Addendum #7

CONSIDER IN YOUR RESPONSE/BID THE FOLLOWING ITEMS OF ADDITION, DELETION OR CLARIFICATION. INDICATE IN THE SPACE PROVIDED ON THE RESPONSE/BID FORM THAT YOU HAVE RECEIVED AND INCLUDED FOR THE REQUIREMENTS OF THIS ADDENDUM. SICKKIDS MAY, IN ITS SOLE DISCRETION ANSWER SIMILAR QUESTIONS FROM VARIOUS RESPONDENTS ONLY ONCE.

RE: QUESTIONS AND ANSWERS, SPECIFICATIONS, DRAWINGS AND DOCUMENTS

2 LEVEL 1 PART PLAN - PLUMBING - NEW WORK
SCALE: 1:50

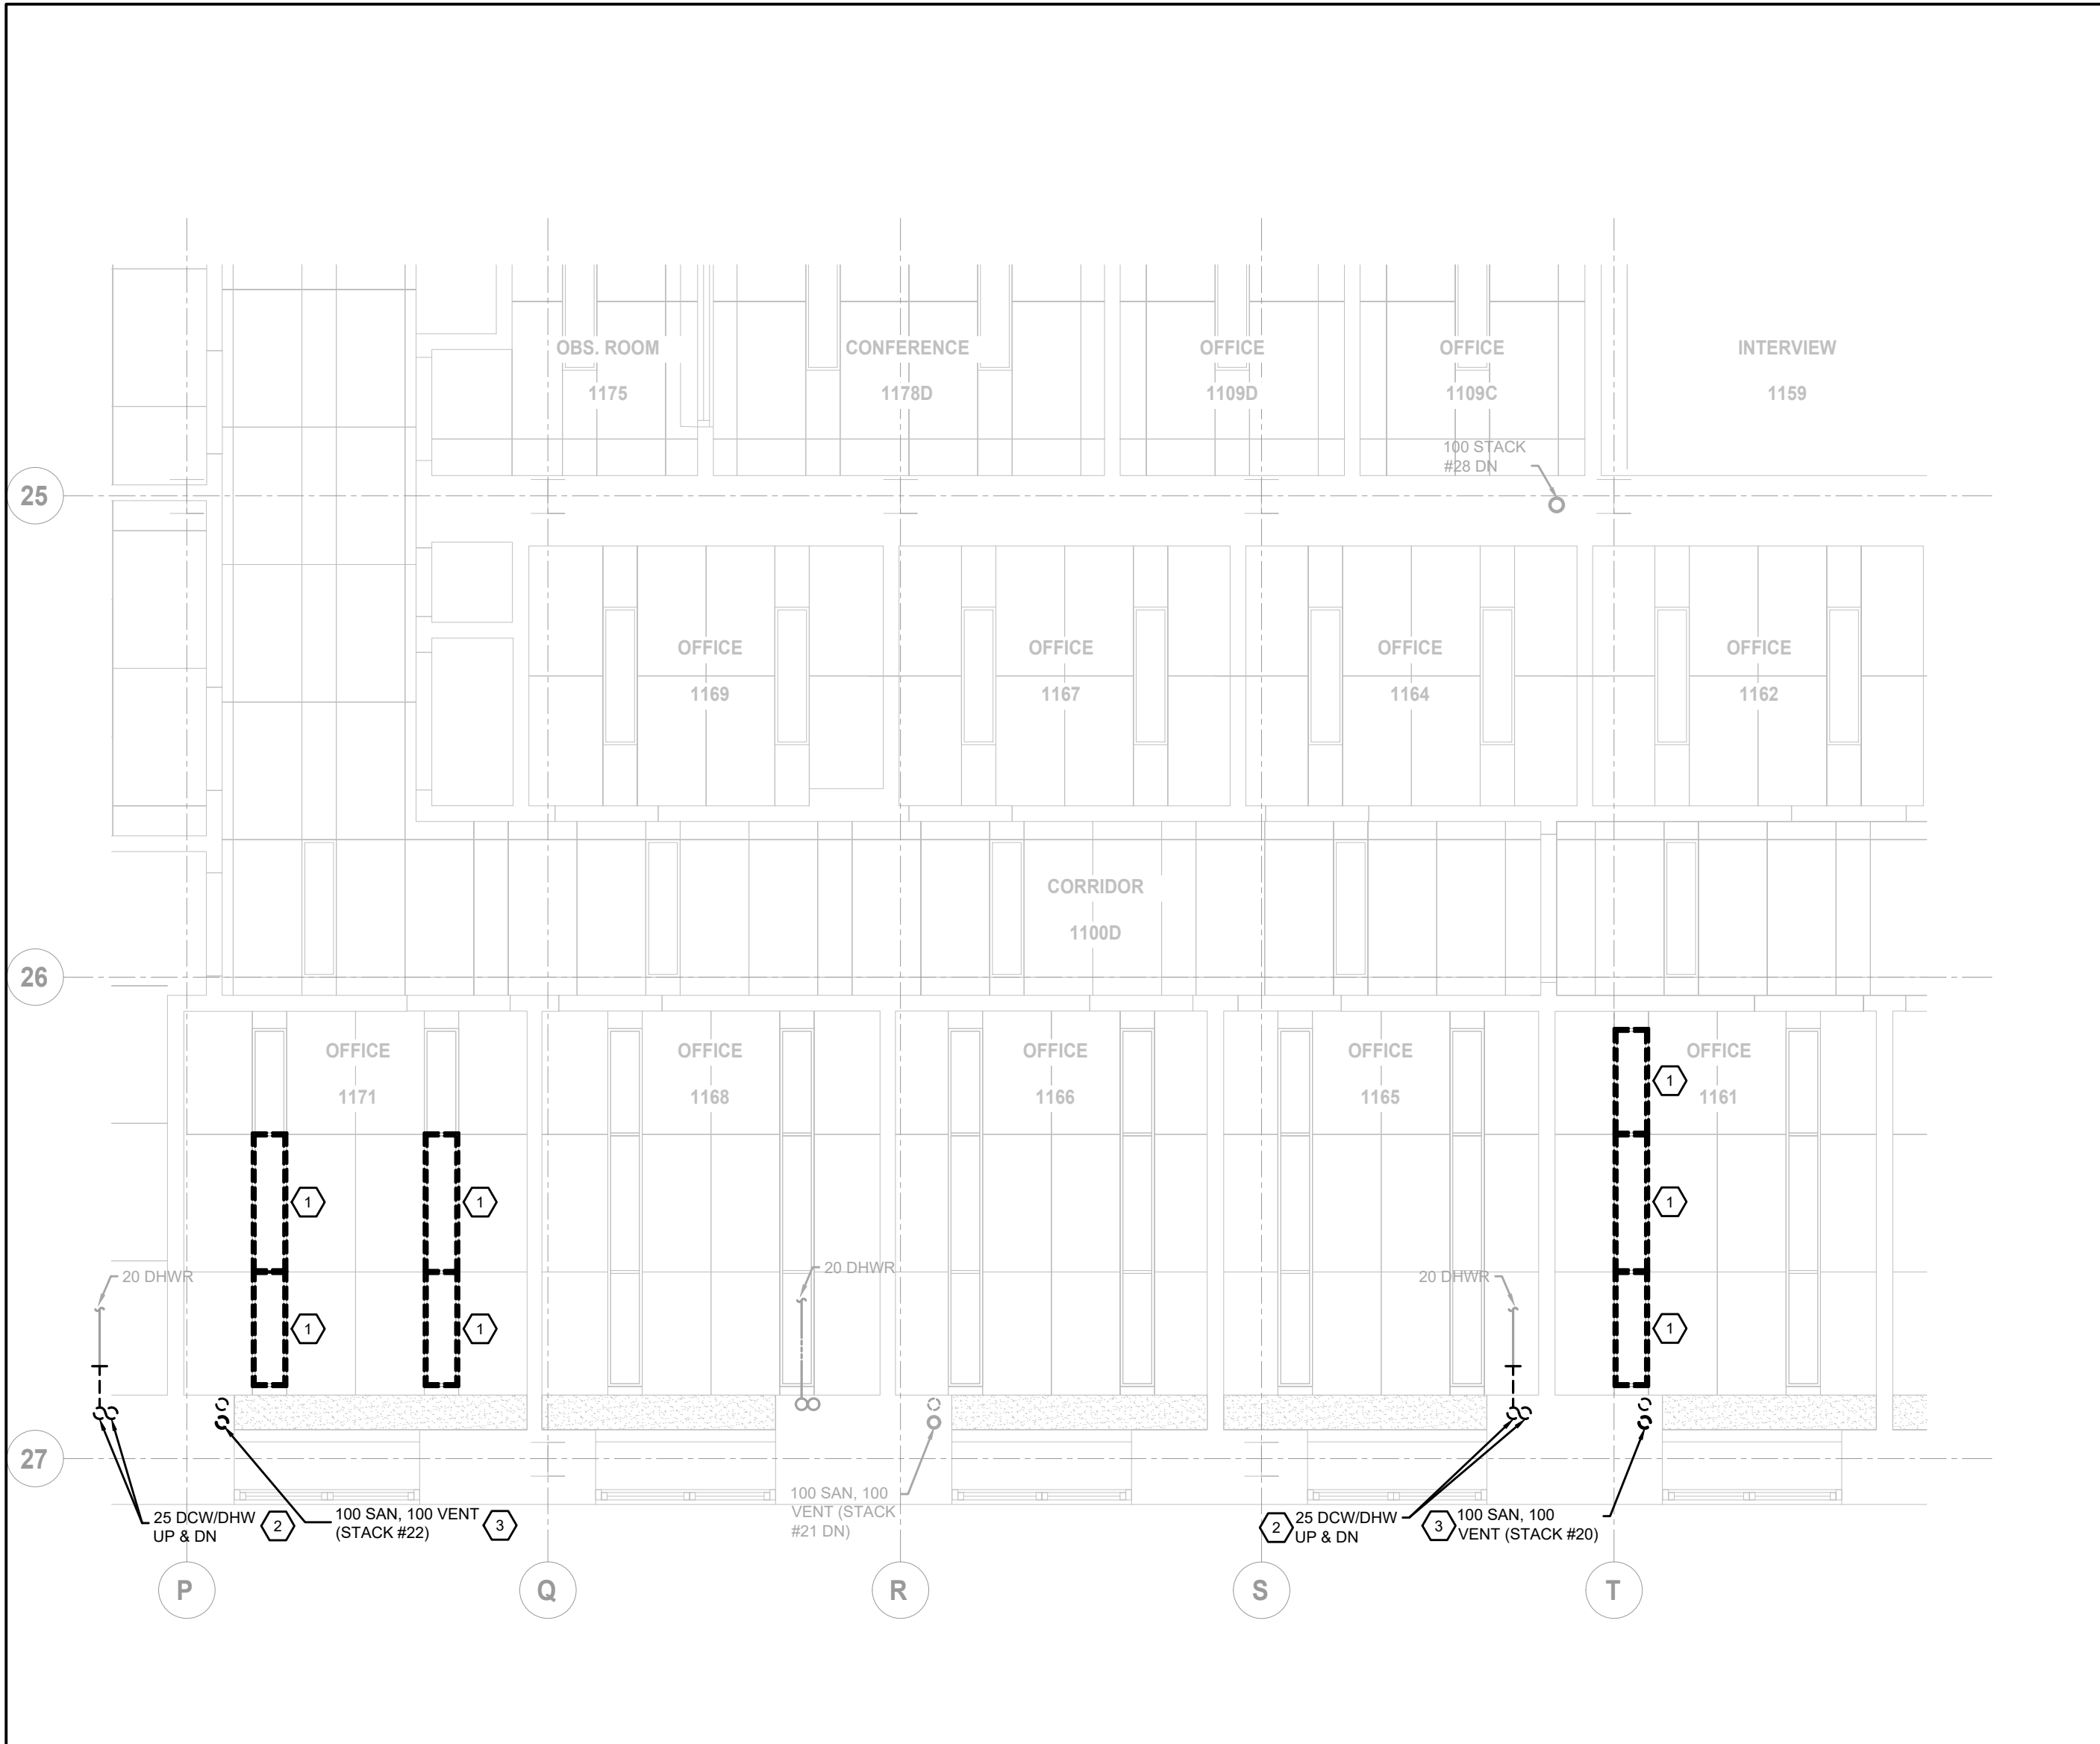
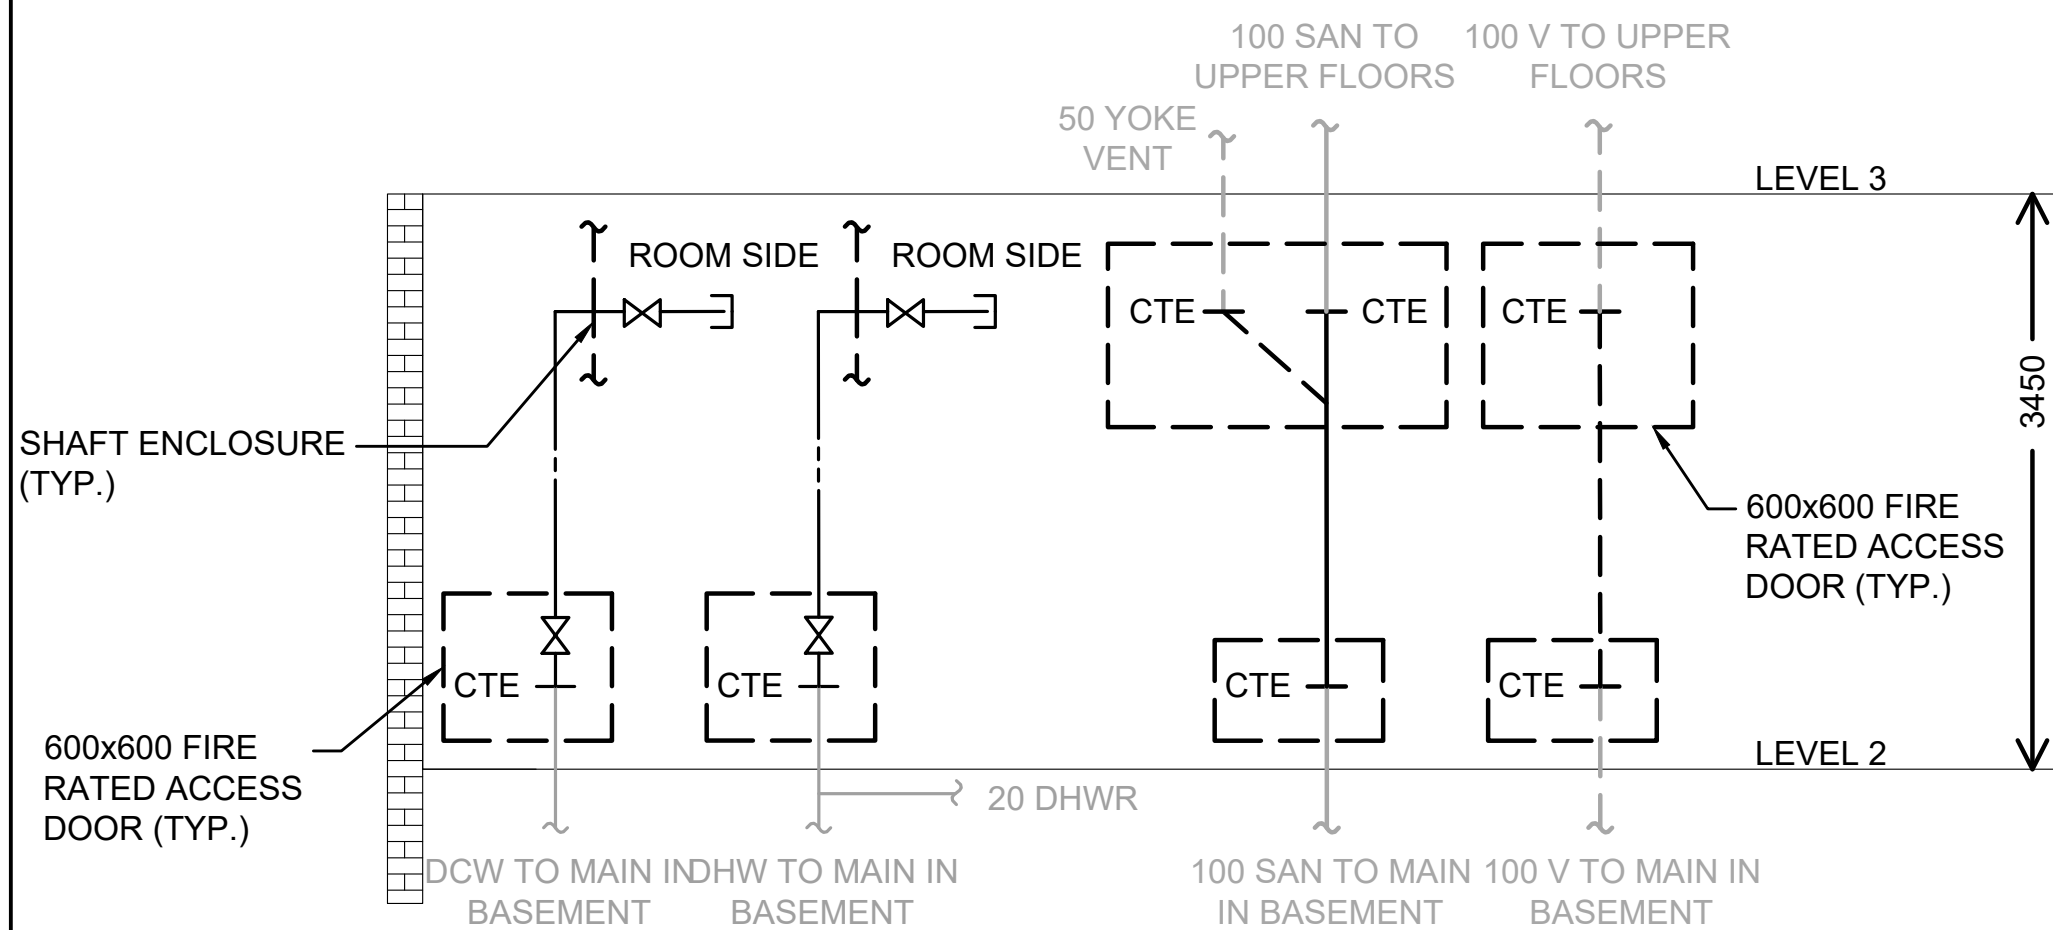
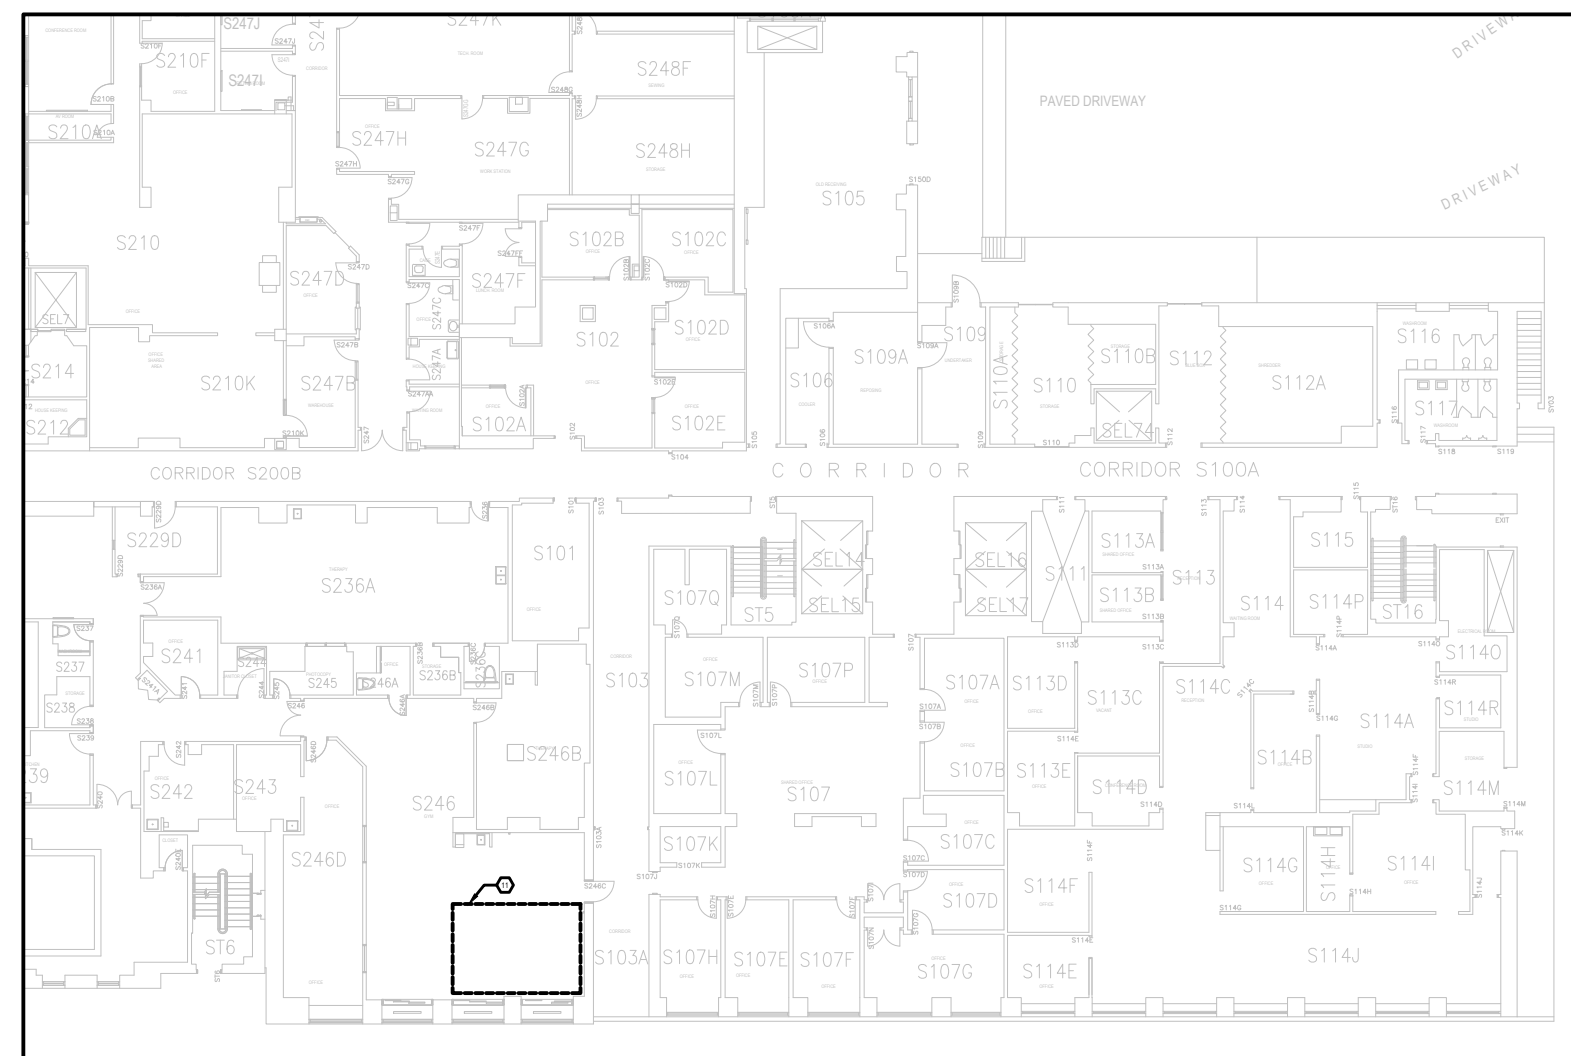
1. **Drawing MA 02 EW 01 – MECHANICAL DRAWING LIST, SYMBOL LIST AND KEYPLAN.**
 - Revisions to drawing list.
2. **Drawing MP 01 EW 01 – LEVEL 1 PART PLANS – PLUMBING – DEMOLITION AND NEW WORK.**

- Revisions to domestic water pipe size.
3. **Drawing MP 02 EW 01 – LEVEL 2 PART PLANS – PLUMBING – DEMOLITION AND NEW WORK.**
 - Revisions to drawing sheet keynotes.
